AGENDA
MANOR PLANNING AND ZONING COMMISSION
105 E. EGGLESTON ST.
MANOR, TEXAS 78653
JULY 8, 2015, 6:30 P.M.

Re: First Construction Plan and Final Plat Review for
Shadowglen Phase 2, Section 20 Subdivision
City of Manor, Texas

Re: Stonewater Subdivision Phase 5
First Final Plat Application Submittal
City of Manor

Re: Stonewater Subdivision Phase 7
First Final Plat Application Submittal
City of Manor

RE: Stonewater Subdivision: Phase 2 - Final Plat Revision Submittal

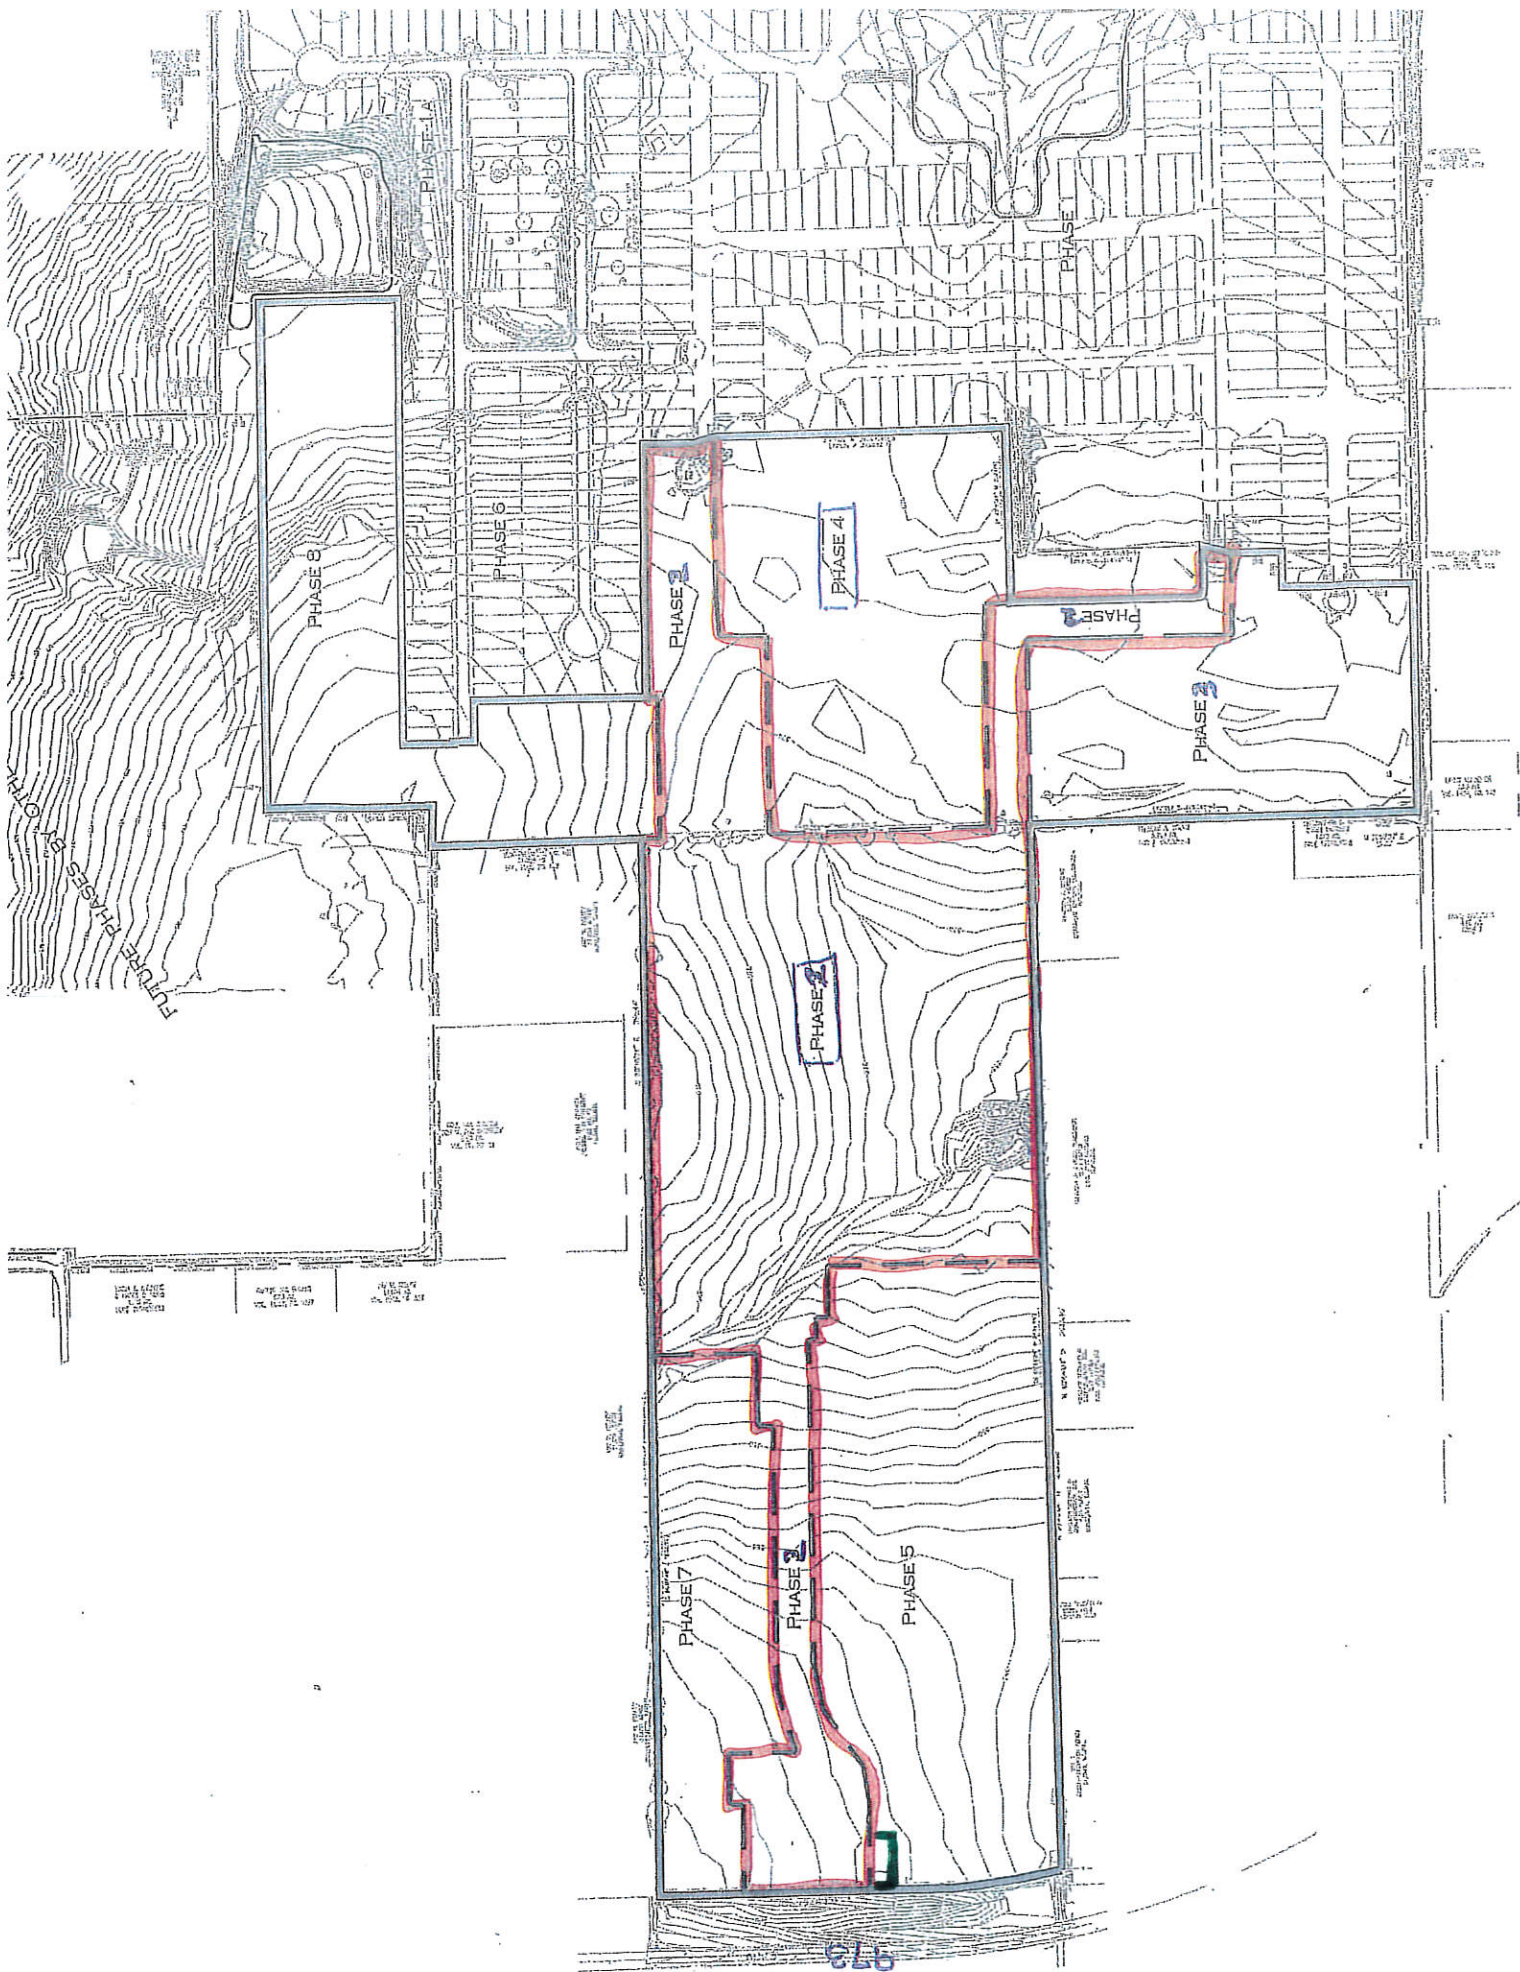
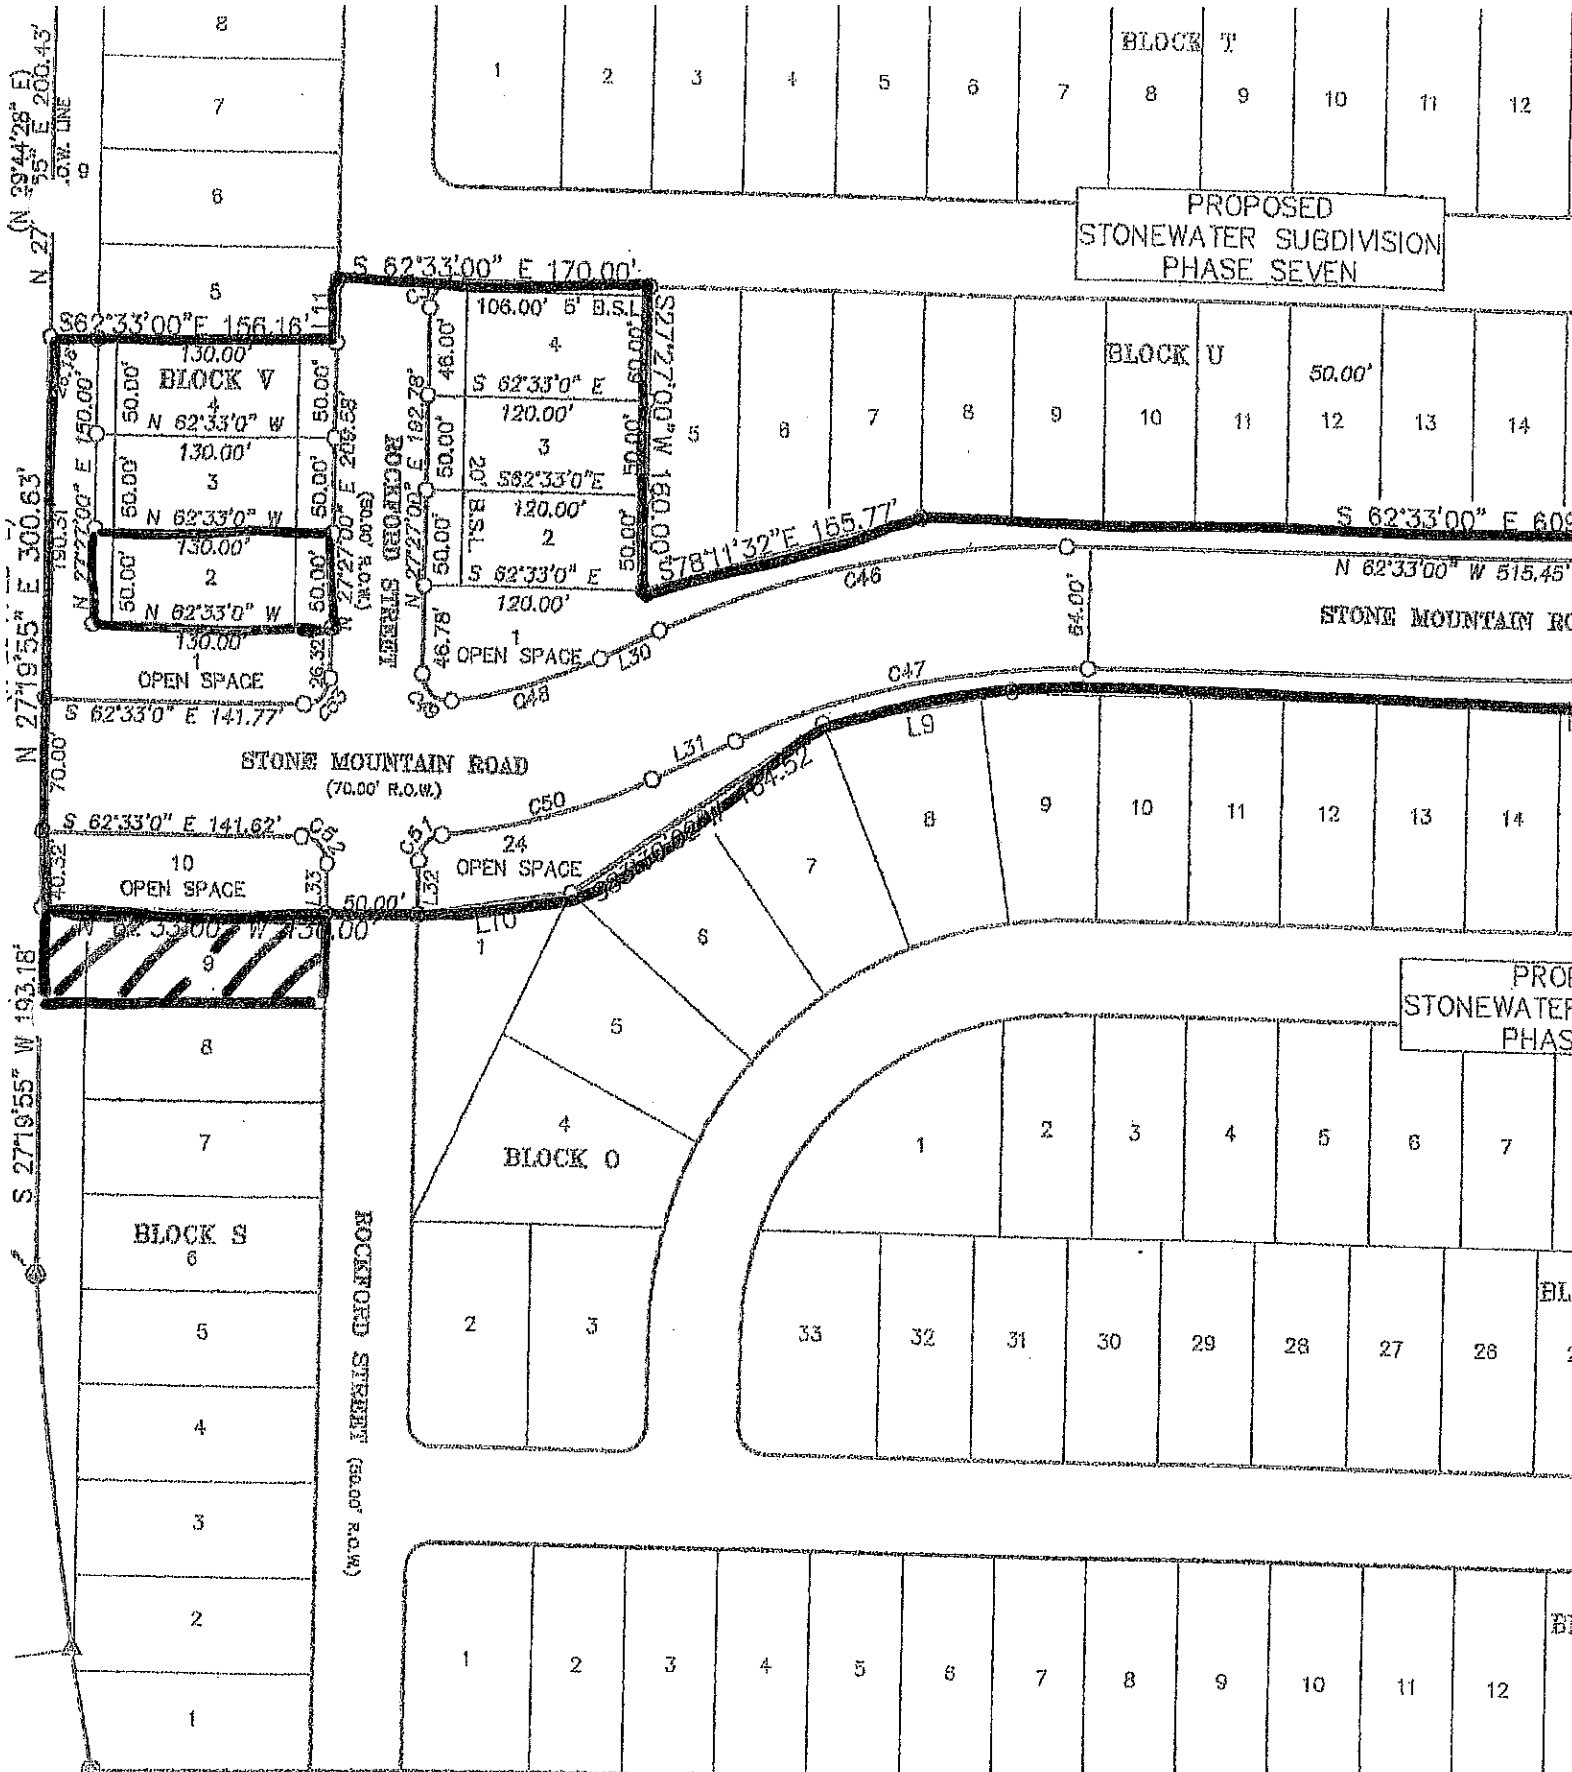
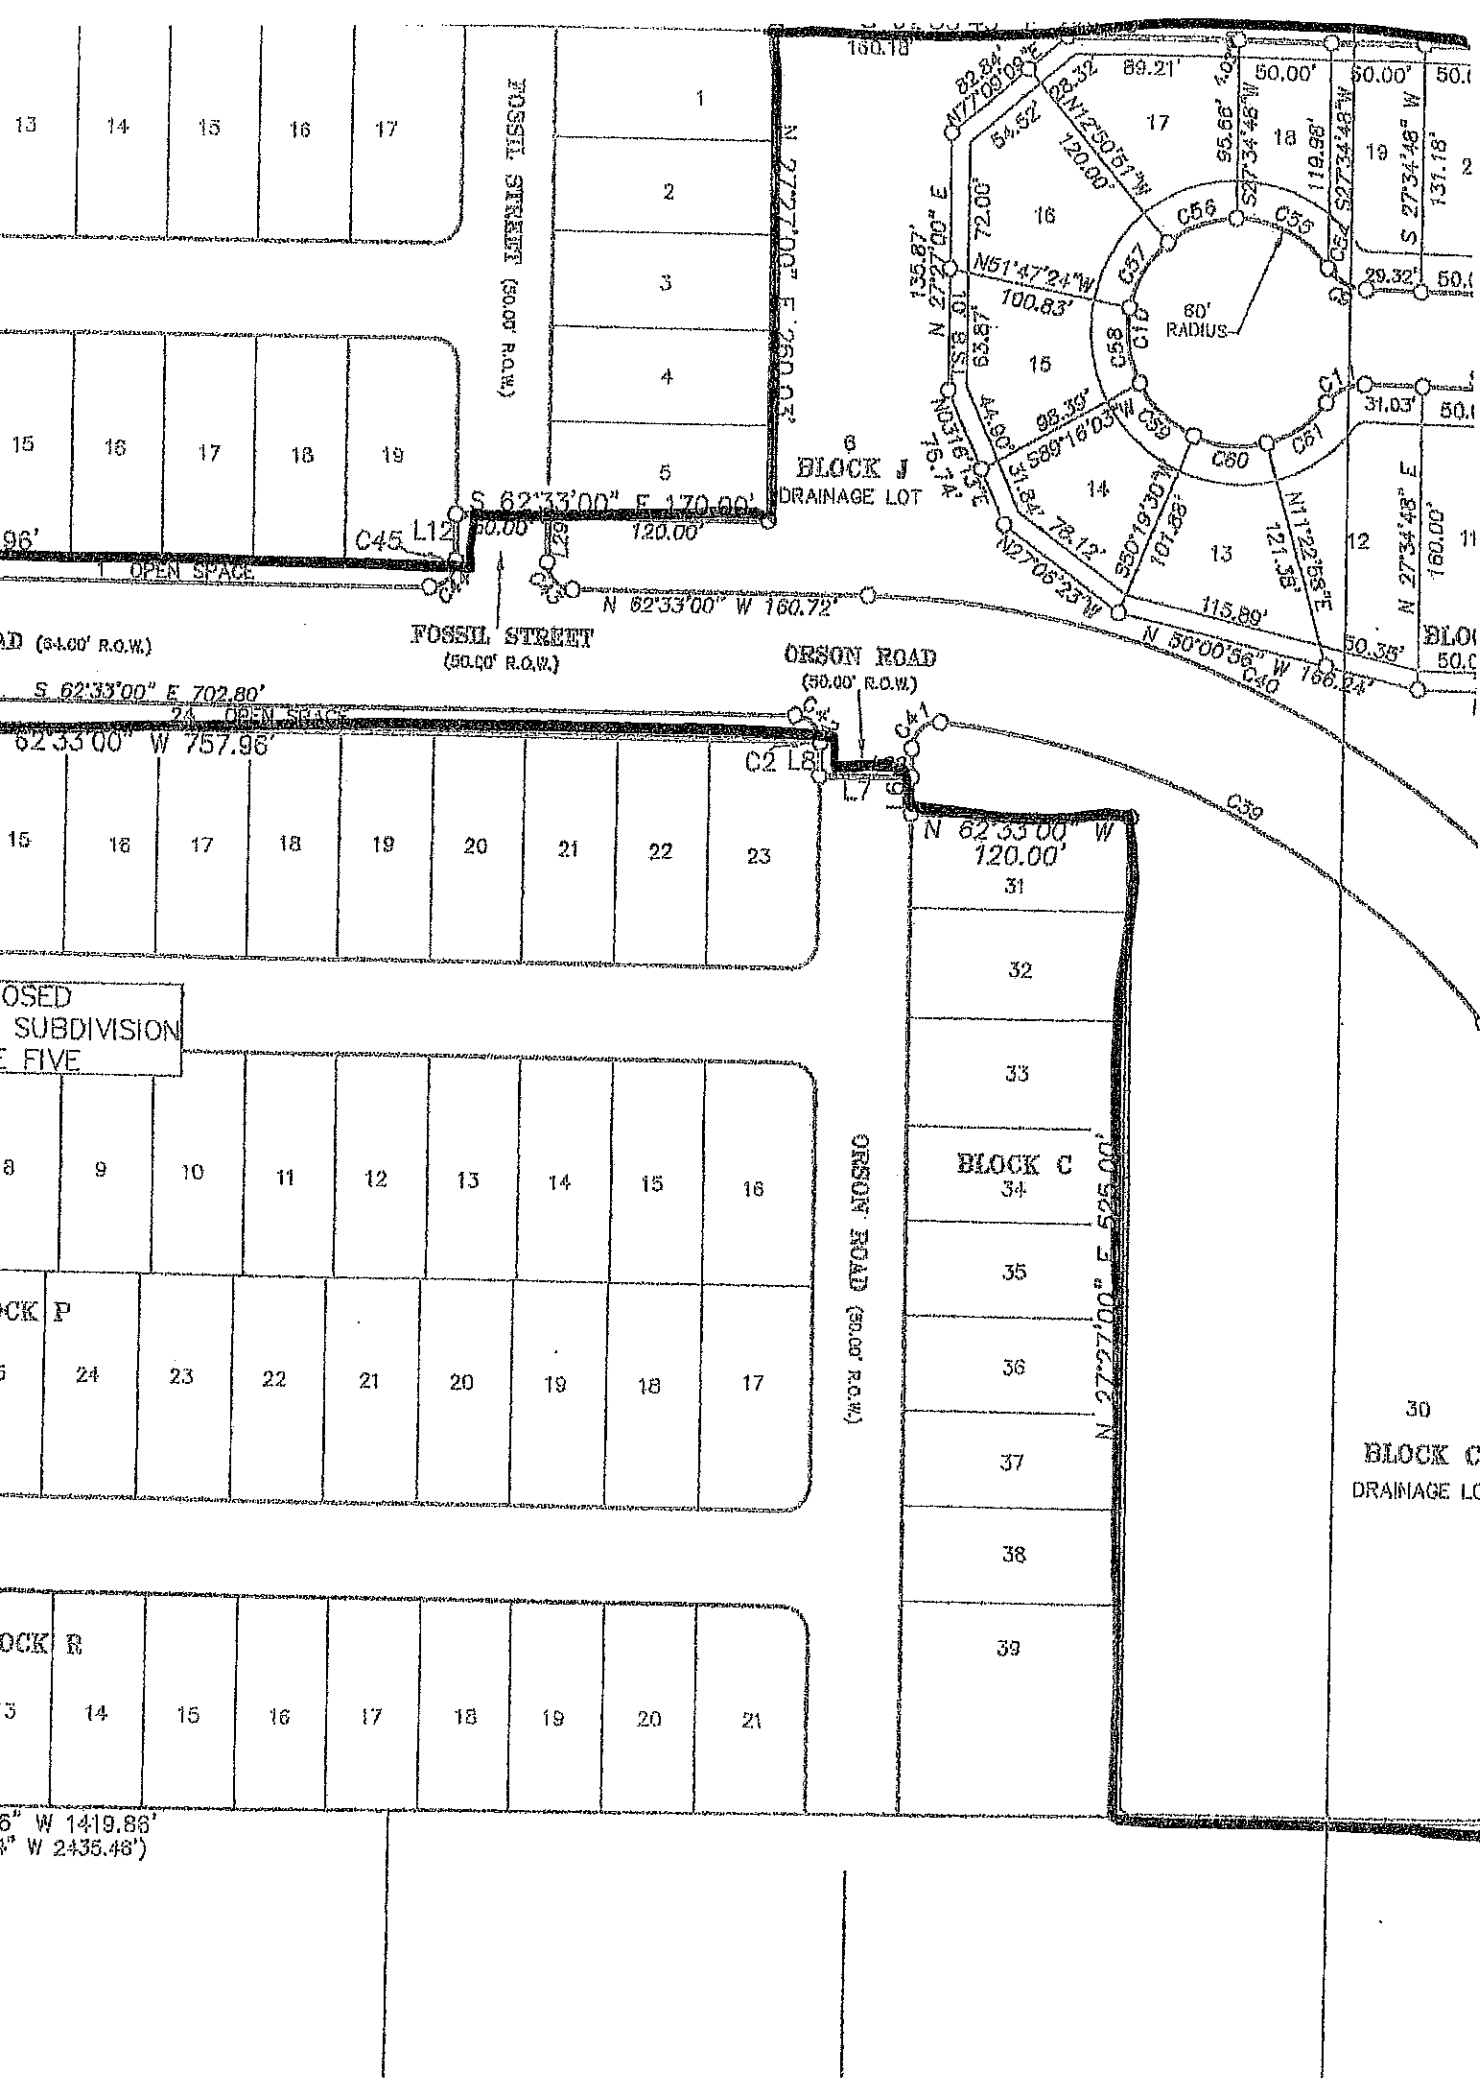
- Lot 9, Block S was previously a part of Stonewater Phase 5 but is now included in Stonewater Phase 2
- Lot 2, Block V & Lot 9, Block S were both residential lots but are now Open Space Lots.
